20-COA-0157
215 Saunders Ave.

Clifton Architectural Review Committee
Public Hearing

Bradley Fister, Historic Preservation Specialist
September 23, 2020 Continued from August 26, 2020

1ST FLR PLAN - DEMOLITION
3/16" = 1'-0" 1

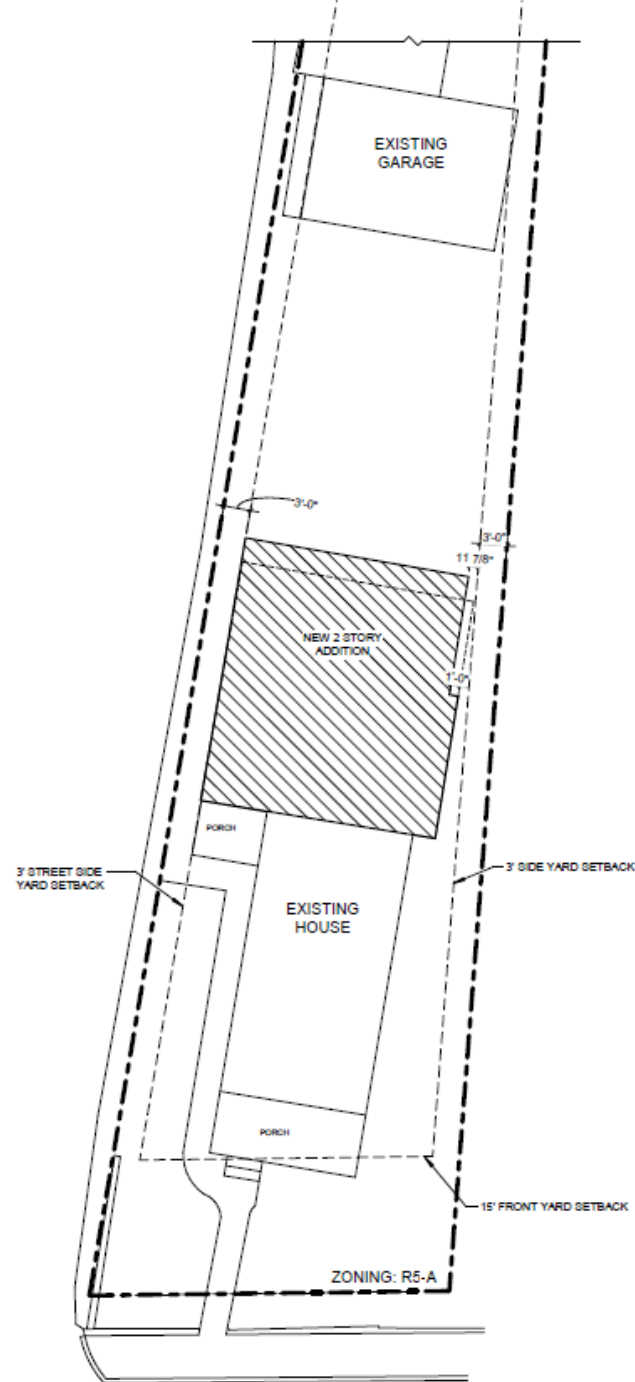
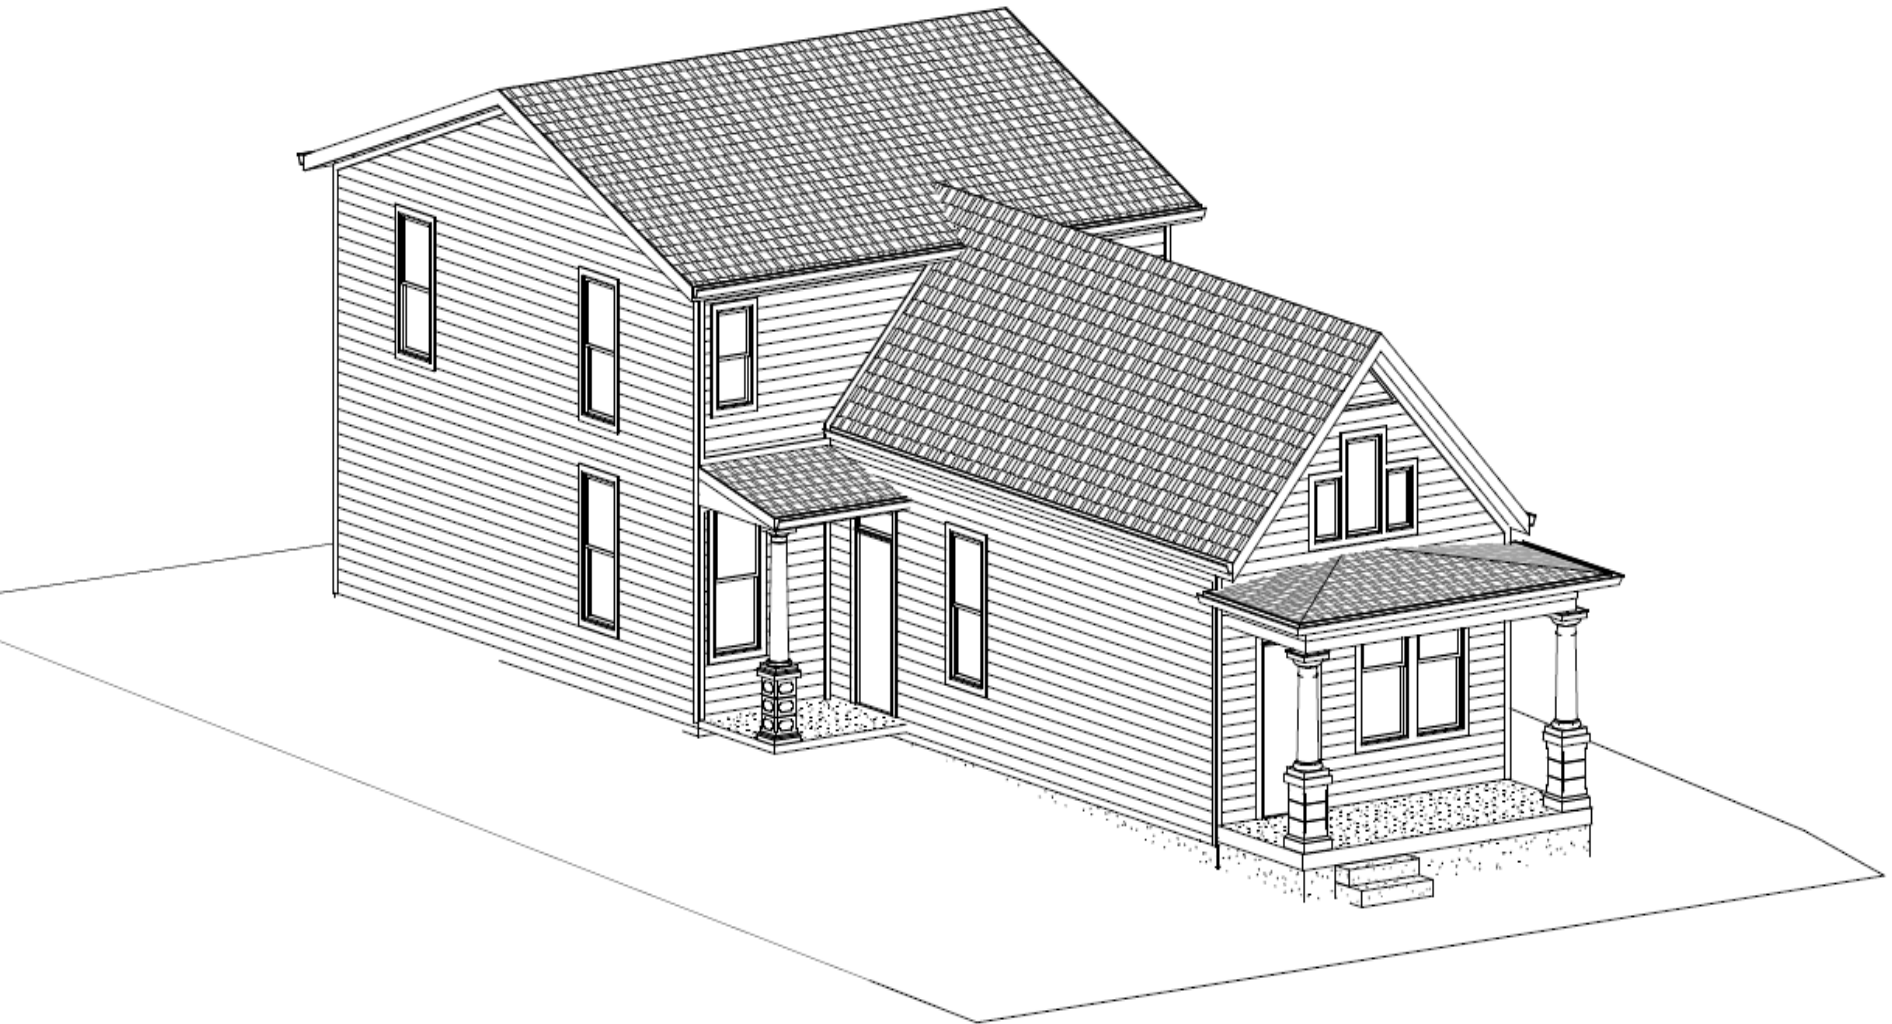
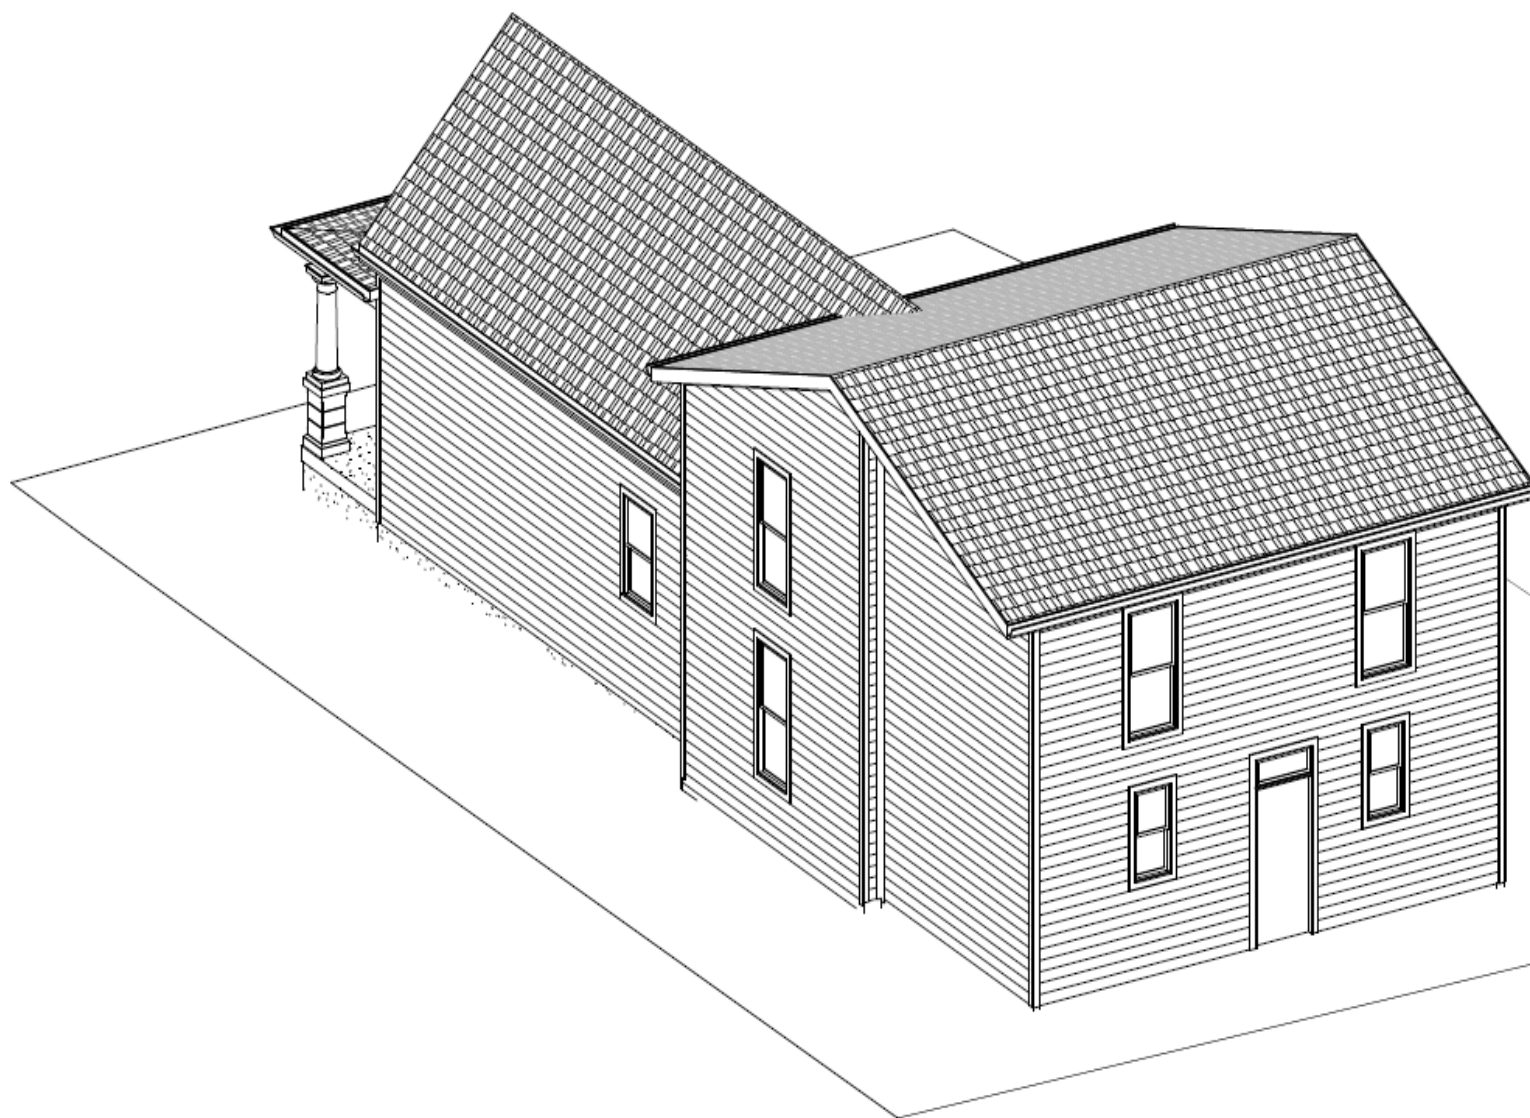
1. After-the-fact demolition of non-original rear, one-story, shed roof house addition at rear of main house (Space will be absorbed as part of new proposal).

Demolition of non-original rear, one-story, shed roof house addition at rear of main house has already occurred prior to this application. The shed addition likely dated to the 1940s or 1950s and had minimal architectural character. It was likely a porch that was enclosed. Since it was a non-contributing addition, it would have been exempt from Committee review due to the amended 2019 Landmarks Ordinance.

WEST ELEV
1/8" = 1'-0"

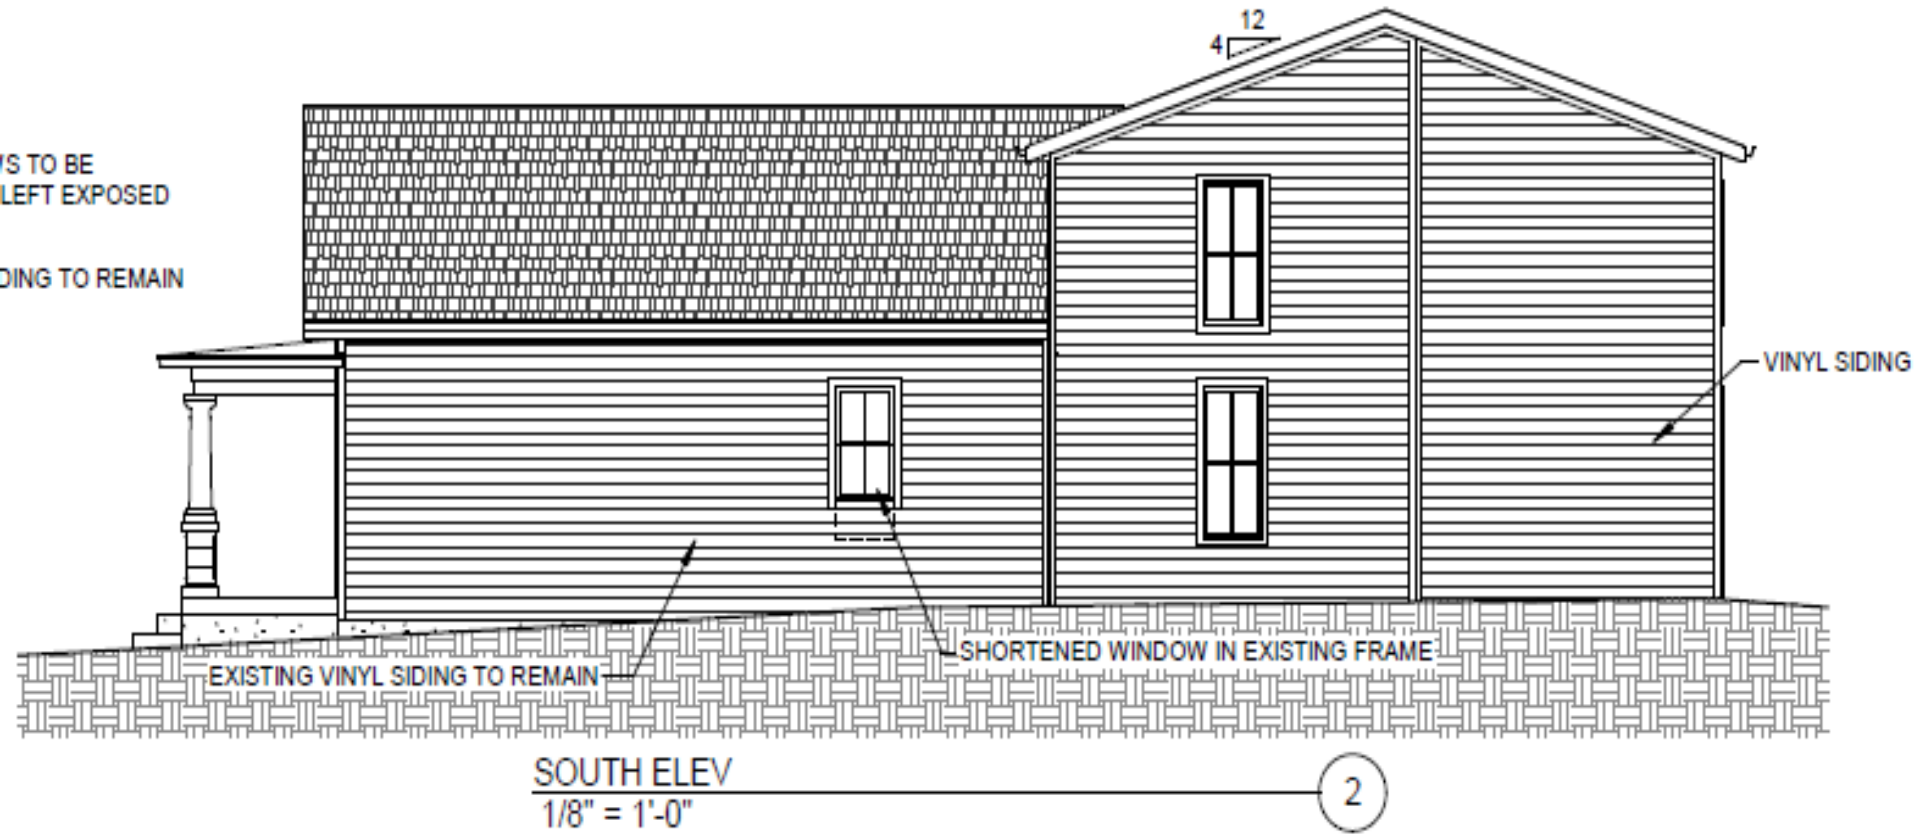
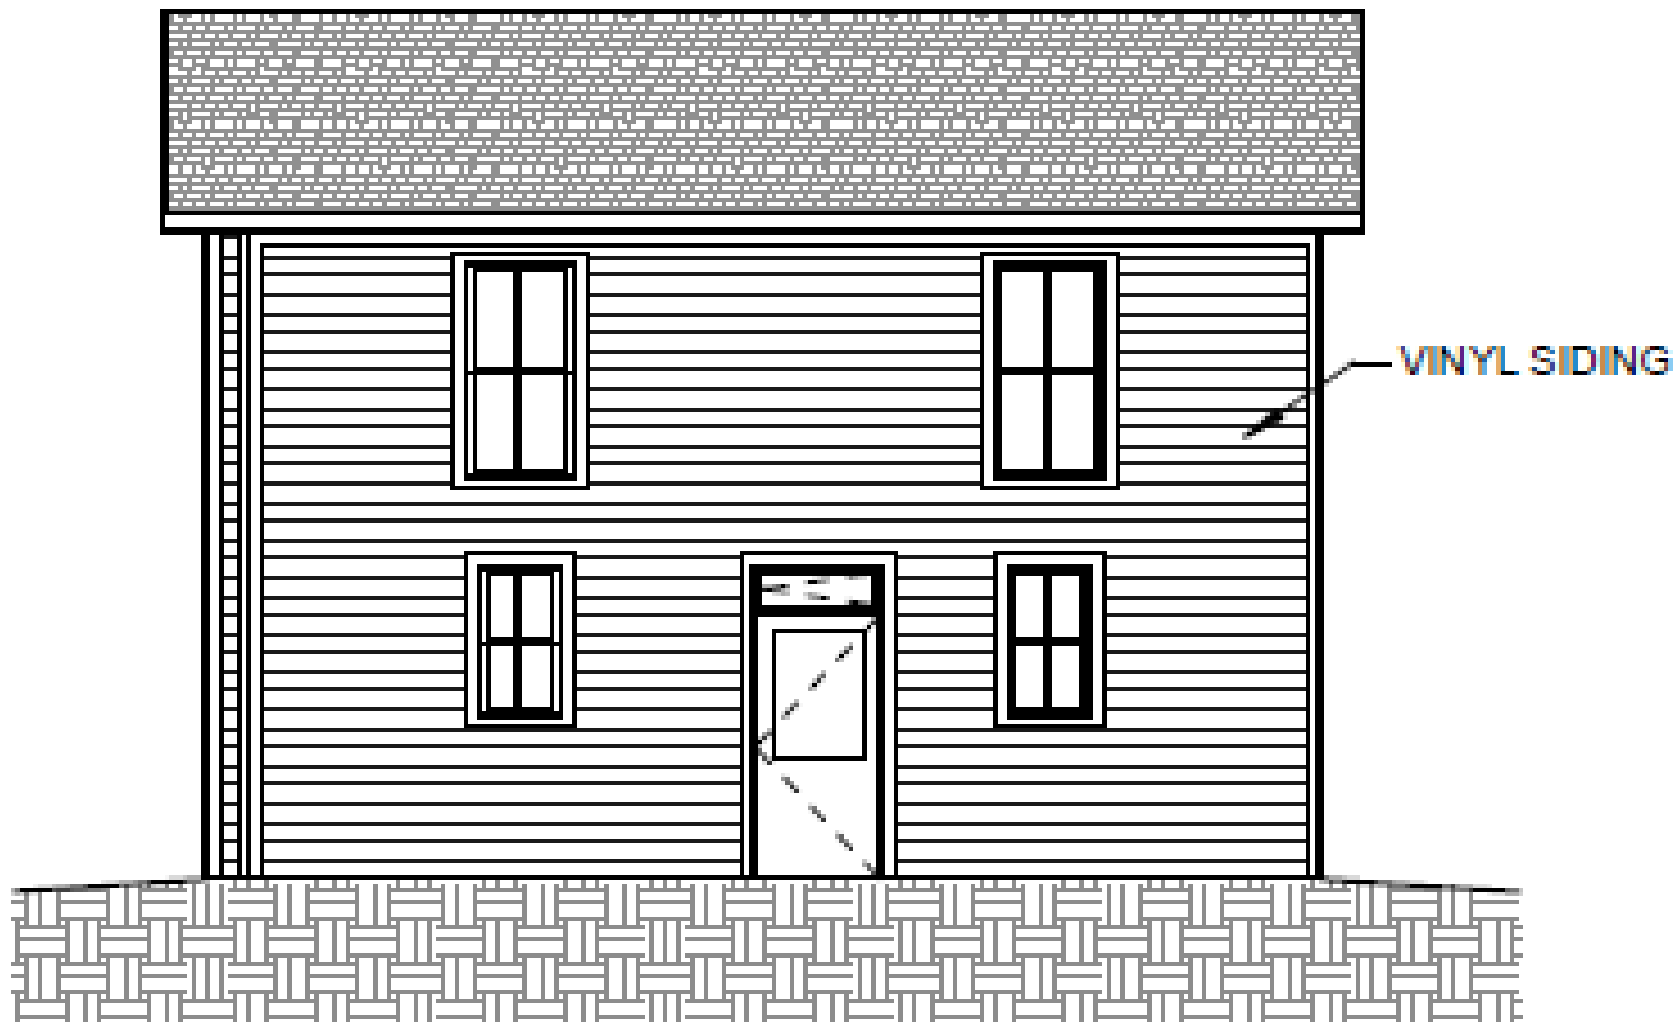
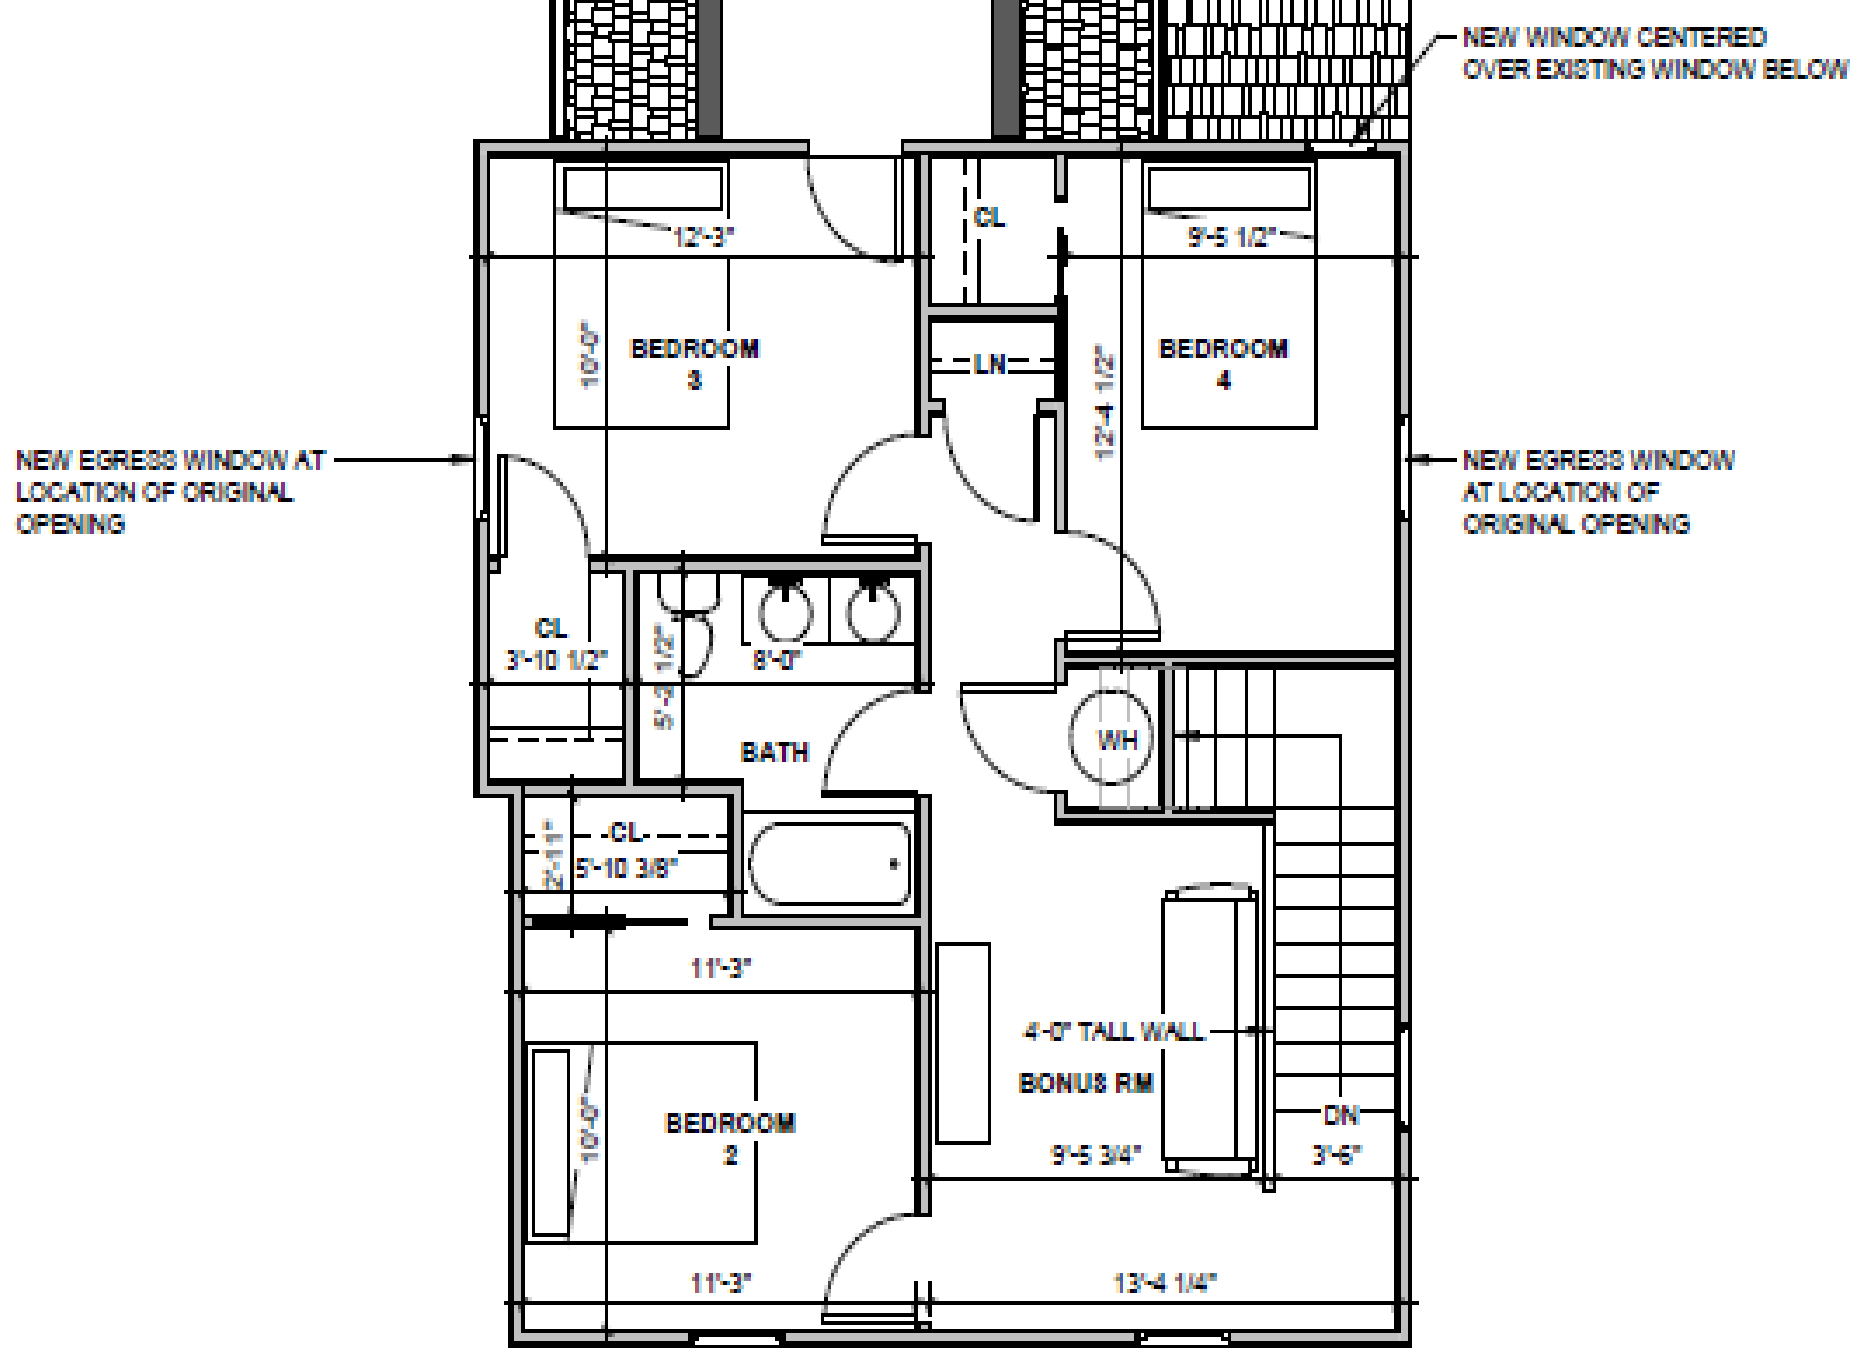
- EXISTING WINDOWS TO BE UNCOVERED AND LEFT EXPOSED
- VINYL SIDING
- EXISTING VINYL SIDING TO REMAIN

The project generally meets the Design Guidelines for Addition and New Construction for Clifton Preservation District. While this rear addition is two-story which is being added to a one-story house, the visual impact of the new addition is minimal to comply with A5. Due to the elevation of the yard, the pedestrian view is upward toward the front shotgun portion of the house which minimizes the view of the 2nd story addition.

Additionally, the accessory structure largely blocking the rear yard, the visibility of the proposed exterior changes are minimized. The orientation of the front gable on the new addition replicates the roof form of the original section of the shotgun house. The existing vinyl siding proposed to be replaced with cementitious fiber siding. Any street-facing windows proposed to be replaced require ARC approval.

1. The main house and addition will feature smooth cementitious fiber siding; maintaining the existing 4” exposure.

2. New roofing materials match the existing roofing material and shingle design and guttering.
3. That above-ground exterior foundation material is smooth-face, poured concrete.
4. Selected windows will be all wood or clad wood with glass muntin dividers, to match configuration of existing house windows. Windows will also (preferably) have simulated divided lite, glass muntin dividers.

5. That there is at least 4” trim casing around all windows and doors of new addition.
6. That construction is executed according to drawings submitted and any changes shall be approved by staff prior to implementation.
7. That the applicant receive all necessary building permits and variances necessary prior to beginning construction.
